REF NO.	AT03010	
DATE	Feb. 19, 2003	
(C)	Page 1 of 4

- SUBJECT: ELIMINATION OF AIR INTAKE HOSE INTERFERENCE ON HD465-7/ HD605-7
- **PURPOSE:** To introduce modification procedure to eliminate the interference of the air intake hose for the engine with the sound absorbing material holding plate on HD465-7 and HD605-7 dump trucks
- APPLICATION: HD465-7 Dump Trucks, Serial Nos. 7001 thru 7058, 7061 thru 7069, 7071 thru 7073 HD605-7 Dump Trucks, Serial Nos. 7001 thru 7024, 7027 thru 7030
- FAILURE CODE: A1M1FA

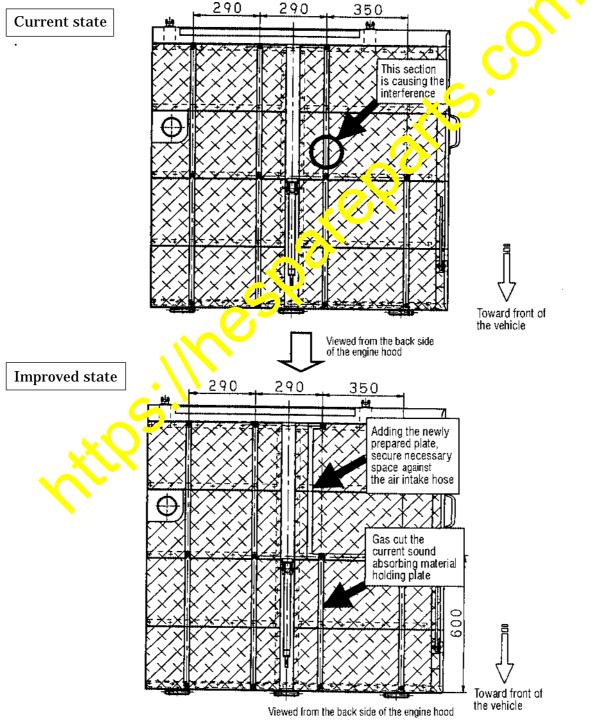
- 4. Modification procedure
- 4-1. Preparation of the necessary parts Prepare the plate referring to Fig. 1 below.

Part number: 569-99-83220 Material: SPHC or equivalent material Sheet thickness: 2.3 mm Q'ty: 1 pce./unit

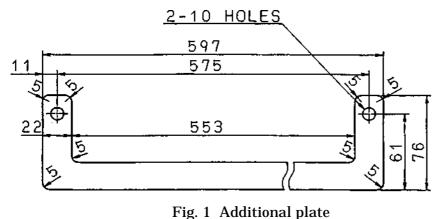
• Details of the modification of the engine hood Gas cut the current sound absorbing material holding plate which is causing interference and add the newly prepared plate to secure necessary space against the air intake hose.

Making the improvement described below, secure necessary space between the air intake hose for the engine and the sound absorbing material holding plate positioned behind the engine hood.

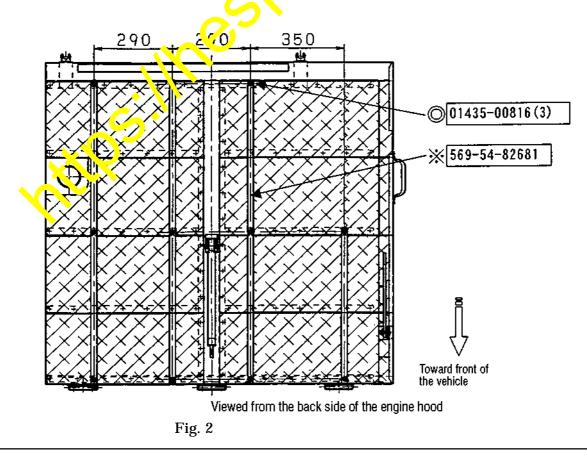
Remove the parts marked \bigcirc and \approx in the drawing. (Refer to Fig. 2.)

Since the parts marked \bigcirc are being residue when installing the improved parts, store them carefully.

Reuse the parts marked % after additional working.

Fig. 4

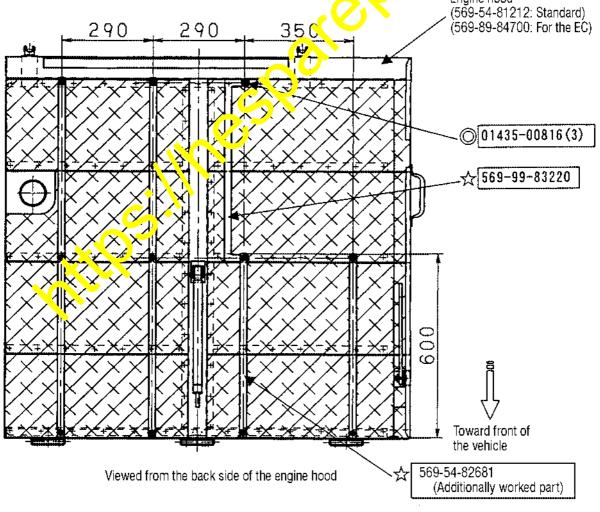
The parts marked \bigcirc are reusing parts, the parts marked \Leftrightarrow are d. tional part and additionally worked part.

- 1) Install the plate (569-99-83220) and the additionally orked plate (569-54-82681) onto the engine hood with the bolts (01435-00816).
- 2) After finishing the installation work, close the engine hood and make sure that the sound absorbing material holding plate does not interfere with the intake hose for the engine.
